Delegated Report (Members Briefing)	Analysis sheet	Expiry Date:	1. 08/03/2021 2. 11/03/2021 3. 22/03/2021 4. 08/03/2021
	N/A	Consultation Expiry Date:	1. 14/06/2021 2. 14/06/2021 3. 12/06/2021 4. 14/06/2021
Officer		Application Number(s)

1. John Sheehy 2. John Sheehy 3. David Peres Da Costa 4. John Sheehy		1. 2021/0162/P 2. 2021/0163/P 3. 2021/0328/P 4. 2021/0161/P	
Application Address		Drawing Numbers

1. 9 Tobin Close, London, NW3 3DY 2. 11 Tobin Close, London, NW3 3DY 3. 12 Tobin Close, London, NW3 3DY 4. 13 Tobin Close, London, NW3 3DY		Refer to Draft Decision Notice	
PO 3/4	Area Team Signature	C&UD	Authorised Officer Signature
Proposal(s)

1. Erection of additional storey (2.8m in height) on existing dwellinghouse, with roof box 3.8m in height above existing roof level. 2. Erection of additional storey (2.8m in height) on existing dwellinghouse, with roof box 3.8m in height above existing roof level. 3. Erection of an additional storey 2.8m in height above existing roof level, with roof box 3.8m in height above existing roof level. 4. Erection of additional storey (2.8m in height) on existing dwellinghouse, with roof box 3.8m in height above existing roof level.			
Recommenda

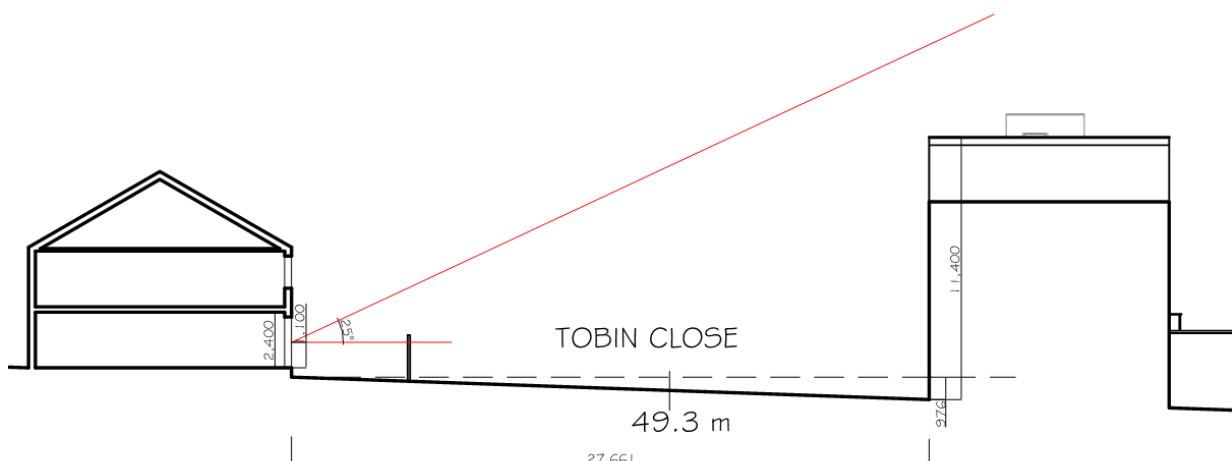
2.3. The residents of 1-8 Tobin Close have objected to the application due to concerns with loss of daylight and sunlight as well as loss of privacy. The site is approximately 27.5m from the rear elevation of 1-8 Tobin Close and approximately 22.6m from the gardens of these properties. There is also a slope so that 1-8 Tobin Close site at a higher level than 9-14 Tobin Close.

2.6. The applicant's daylight and sunlight submission demonstrates that the proposed development would be below the 25 degree line (as shown below). The BRE guidance states that if this angle is less than 25 degrees for the whole of the development then it is unlikely to have a substantial effect on the diffuse skylight enjoyed by the existing building.
